**STATE OF DELAWARE  
EXECUTIVE DEPARTMENT  
OFFICE OF STATE PLANNING COORDINATION**

March 21, 2011

**RE: PLUS review – 2011-02-01; Silver Woods**

According to the information received, you are seeking a rezoning of 115.5 acres from GR to MCPC for a mixed use residential community consisting of 178 residential units and 70,225 sq. ft. of commercial space. It is noted that you intend to annex this property into the Town of Ocean View. The Town should work with this office to ensure that a Plan of Services form is completed and approved prior to annexation.

**Figure 1:** 2009 USDA aerial photography of the proposed project

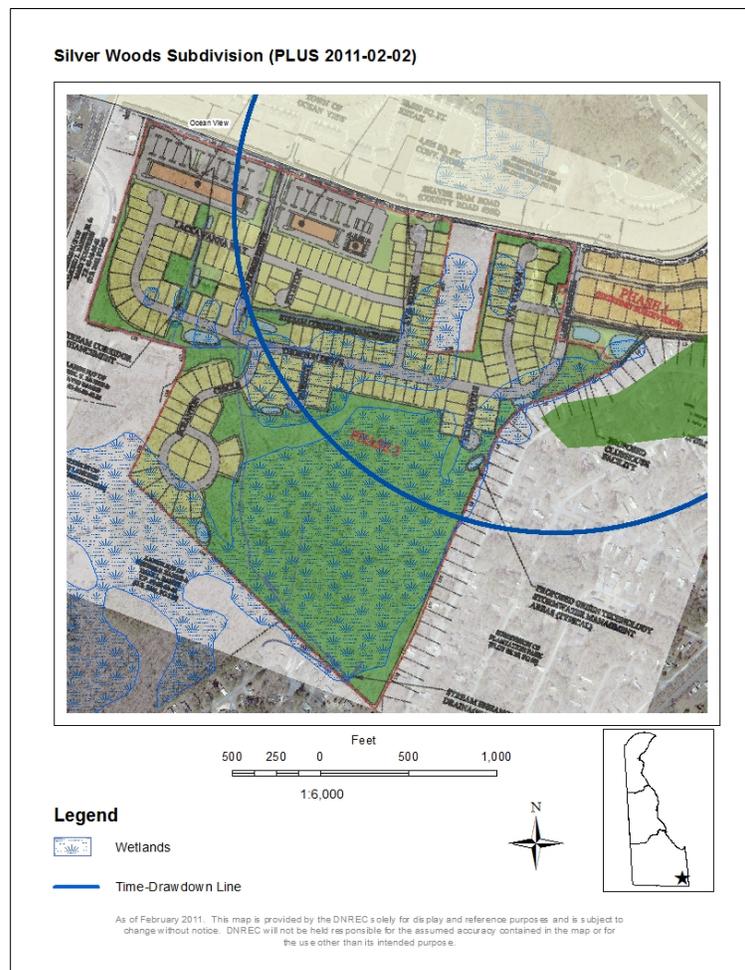
- According to the Statewide Wetland Mapping Project (SWMP) maps, palustrine wetlands (PFO1A, PSS3/F01A & PEM1C et al.) were mapped throughout the proposed project area (Figure 1). Most of the wetlands on this site are forested (See figures 1 & 2).

- Based on a review of existing buffer research by Castelle et al. (Castelle, A. J., A. W. Johnson and C. Conolly. 1994. *Wetland and Stream Buffer Requirements – A Review*. J. Environ. Qual. 23: 878-882.), an adequately-sized buffer that effectively protects wetlands and streams, in most circumstances, is about 100 feet in width. In recognition of this research and the need to protect water quality, the Watershed Assessment Section recommends that the applicant maintain/establish a minimum 100-foot upland buffer (planted in native vegetation) from all water bodies (including ditches) and wetlands (See figure 1).

**Figure 3:** Soils mapping in the immediate vicinity of the proposed project

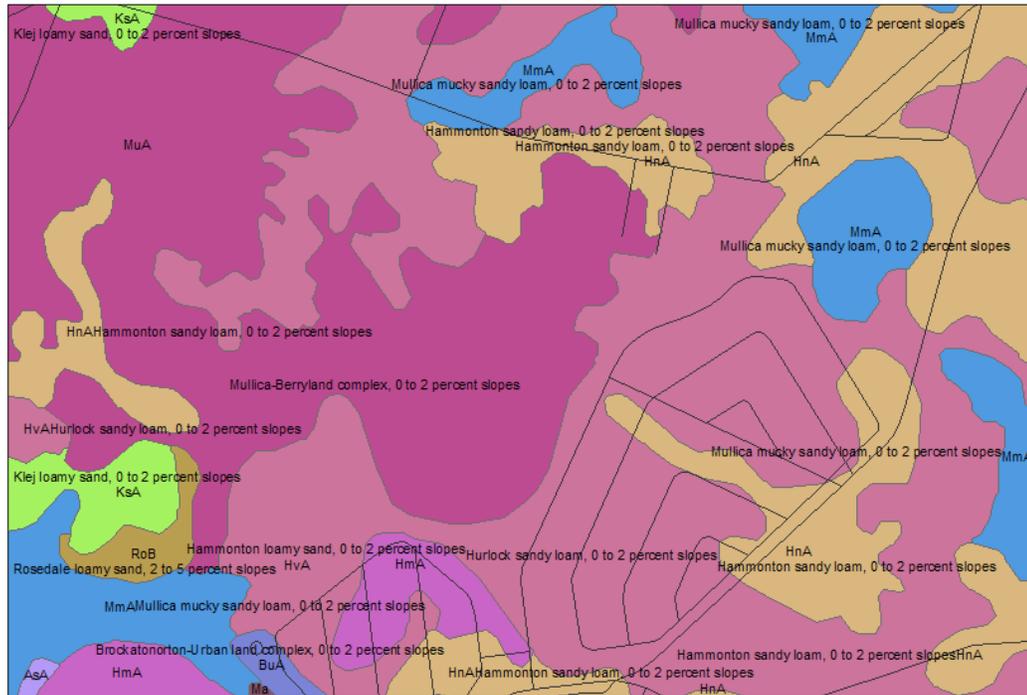
- Based on soils survey mapping update, Mullica-Berryland complex (MuA) and Hurlock (HvA) are the principal soil mapping units that were mapped in the immediate vicinity of the proposed project area. Mullica-Berryland complex and Hurlock are wetland associated (hydric) soils that have severe limitations for development, and are considered unsuitable for development. Building on such soils is likely to increase both on-site and off-site flooding potentials (See figure 3).
